**LETTER OF OBJECTION TO DA2025/0447**

**Demolition and construction of a residential flat building containing eleven (11) units with basement car parking, rooftop swimming pool and associated site works.**

I refer to the above Development Application (DA) for 32 Golf Avenue, Mona Vale (the development site).

*Figure 5. High retention value trees located on 28-30 Golf Avenue*

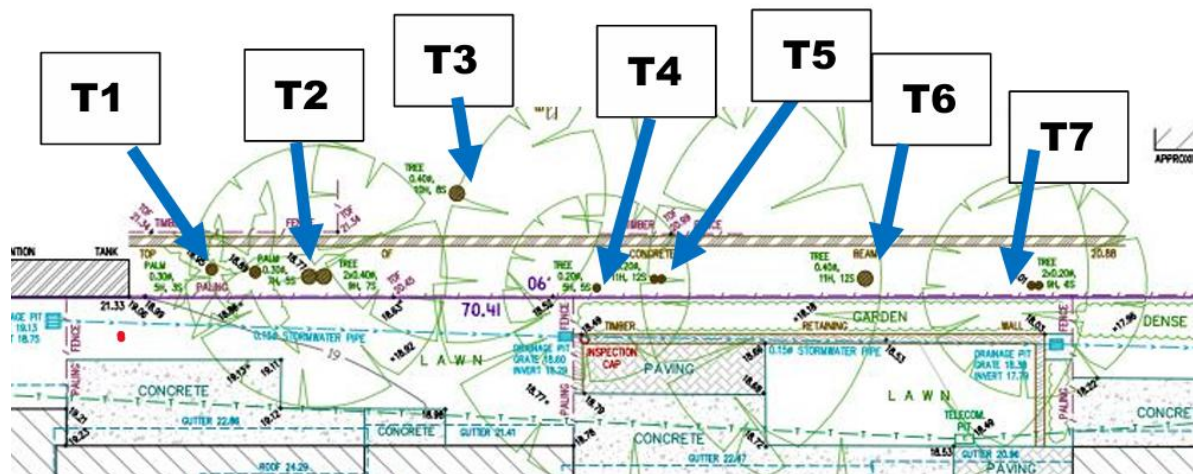
As seen in Figure 5 below, there is a row of seven healthy trees on 28-30 Golf Ave, adjacent to the common boundary. The Arboricultural Impact Assessment (AIA), prepared by Selena Hannan, identified these trees as Trees 1- 7 (Tuckeroos and Lillypillies) and classified them as H = high retention value.

The AIA claims that Trees 1 - 7 will be retained. However, this is based on an incorrect assumption of the basement setback being 3.5m. The AIA states the excavation for the basement “is 3.5m of Trees 5 and 6, which is a 13% and 11% encroachment in the TPZs, which is a theoretical marginal impact on the root systems of these two trees.” However, the actual setback of the basement is 3m. Moreover, the Geotechnical Report (by Crozier) states that the basement level excavations will be set back from the western boundary by 2.40m.

Given the depth of excavation (6.7m) and the anticipated need for pre-excavation support in the form of a soldier pile wall or similar, the incursion into the TPZ is expected to be greater than that adopted in the AIA. Therefore, serious concerns are raised regarding the retention of Trees 1 and 7.
